DATE: 03.27.2019
TO: ProTrak
FROM: Mitesh Baxi
Traffic Engineering

■ **BIRCHWOOD DRIVE ACCESS PLAN [TRC Plan Review #2]**

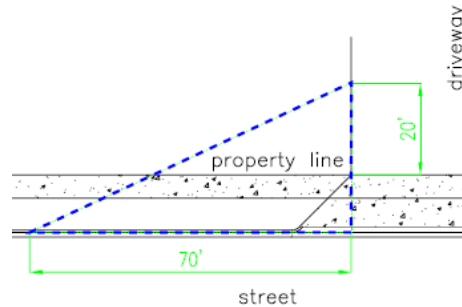
1. The City's 20'x70' sight distance triangle at the driveway is not shown as per City standard (below image) but it covers the area that would have required as per 20'x70' sight distance triangle. A separate review is not required. Please revise as per below image with the final submission. [\[Sec.18-529\(c\) \(3\) CofW LDC\]](#) [\[Sec. 18-812 CofW LDC\]](#).
